SUMMARIZATION OF NEW APPENDICES (B, C, D, E, F, G, H)

DATE: June 15, 2026

RE: Supplemental Public Comments and Risk Assessment regarding the Proposed 20 MGD Wastewater Treatment Facility

LOCATIONS UNDER CONSIDERATION: Sites 1 through 7 — Mann Road, Berea Church Road, and Coles Ferry Pike corridor, Lebanon, TN

Exhibit C-1: 0.5-mile, 1.0-mile, and 2.0-mile rings centered on 3230 Mann Road, plotted on the TDEC Water Wells Desktop Application map. Each dark dot represents a permitted private water well in the TDEC database.

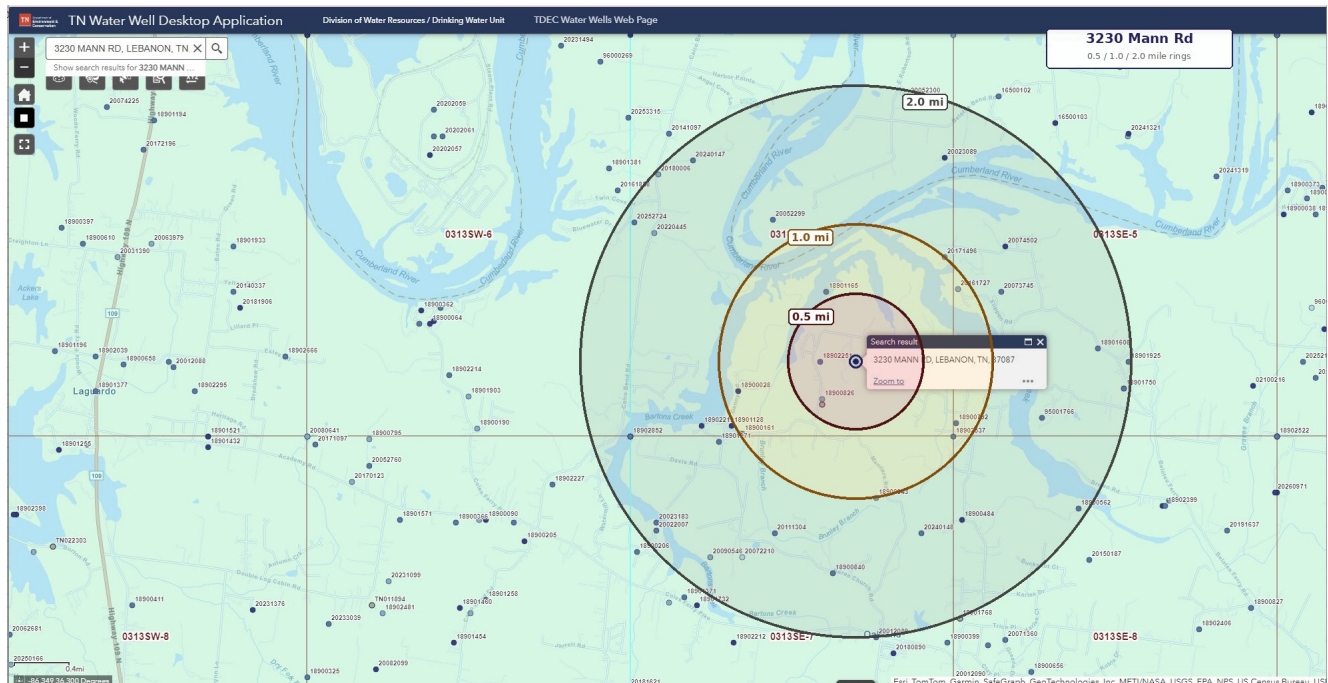
A query of the Tennessee Department of Environment and Conservation (TDEC) Water Well Locations public database identifies **a minimum of 38 permitted private wells within the 2-mile contamination radius** surrounding the proposed Mann Road and Berea Church Road footprint. Of these:

- **6 wells are located within 0.5 miles** of a proposed site, including a well at 1079 Berea Church Road (Coster) situated approximately 850 feet (0.16 mi) from the Mann Road site;
- **16 wells are located within 1.0 mile** of a proposed site;
- **38 wells are located within 2.0 miles** of a proposed site, the outer boundary of the karst contamination radius identified in Section VI.

The geographic distribution of these wells, with concentric 0.5-mile, 1.0-mile, and 2.0-mile rings, is depicted in Exhibit C-1 below. Recorded uses include residential drinking water (32 wells), agricultural and irrigation (9 wells), and geothermal heat pump (3 wells). The Site Selection Committee has not, to the petitioners' knowledge, entered these figures into the public record.

Important caveat: The figure of 38 wells is a minimum. The TDEC Water Well Locations database includes only those wells for which a licensed driller filed a report. Wells drilled prior to the

- Formally request a hydrogeological study from a qualified third party documenting (or refuting) hydraulic connectivity between the proposed site footprint and the LUD well field;
- Require coordination with the LaGuardo Utility District Board of Commissioners as a prerequisite to any further consideration of the Mann Road and Berea Church Road addresses;
- Enter the well-count data and accompanying ring map (Exhibit C-1) into the official public record of the site selection proceedings, and supplement it with an independent staff verification against the most current TDEC Water Well Locations database;
- Provide written notification to each identified well owner, and to all LUD ratepayers, of the proposed siting and the karst-aquifer contamination pathway described in Section VI of the principal statement.
